BID ADDENDUM No. 3

Re: Bond Improvements Phase 2
Briarcliff Manor Union Free School District
SED No. 66-14-02-02-0-004-023 (HSMS)
SED No. 66-14-02-02-0-002-021 (ES)
BBS File No 21-274C, 21-274D

Phase 2 Bond Improvements at Briarcliff Manor MS/HS and Todd Elementary School

E4.01

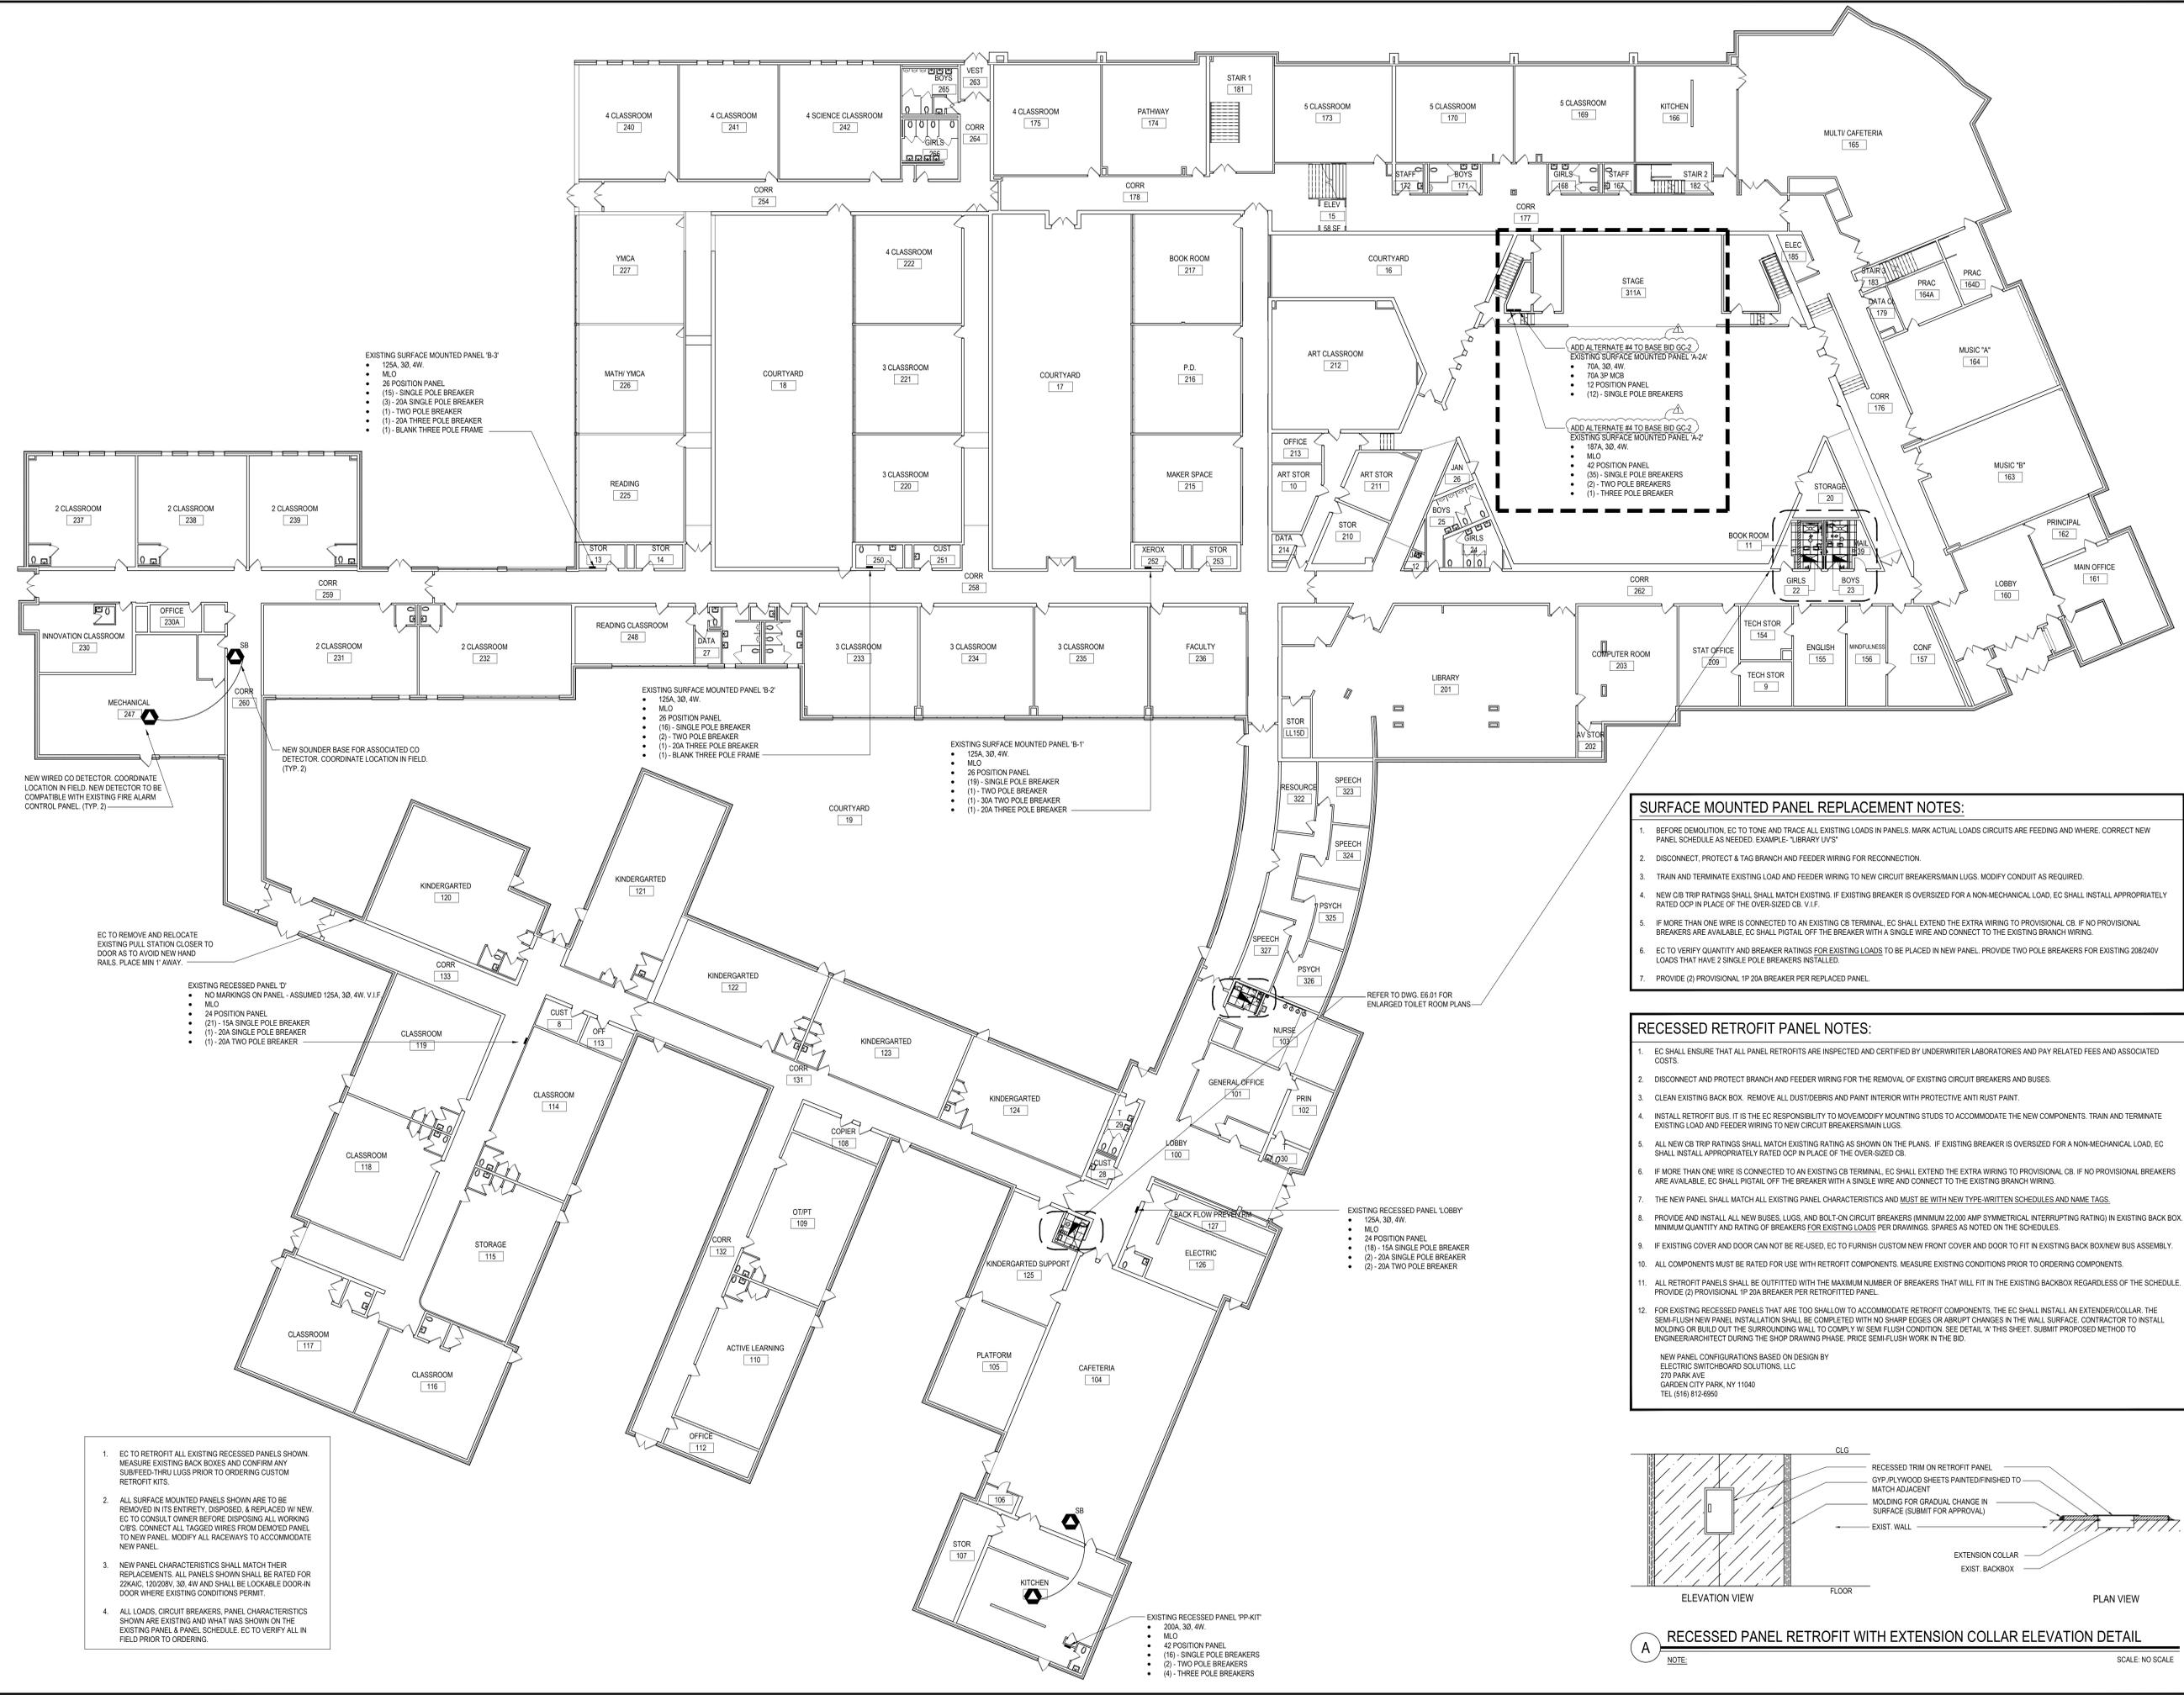
1. Drawing E4.01 ROPOSED PANEL REPLACEMENT, CO DETECTION, AND MISCELLANEOUS PLANS
 - a. Construction Drawing is hereby deleted and replaced with the attached.

1. **Question:** Drawing E4.01, Stage 311A, has two (2) panels to be replaced as part of Alternate #1. The bid proposal does not have an alternate for this scope of work.

BBS Response: Refer to revised bid proposal form include in this addendum for alternate #4 to Base Bid GC-2. Refer to revised drawing E4.02 for Todd Elementary included in this addendum.

The General Contractor shall state the complete price to be **(added to)** the base bid to provide electrical panel replacements at Stage 311A as shown on drawing E4.01 and specified herein.
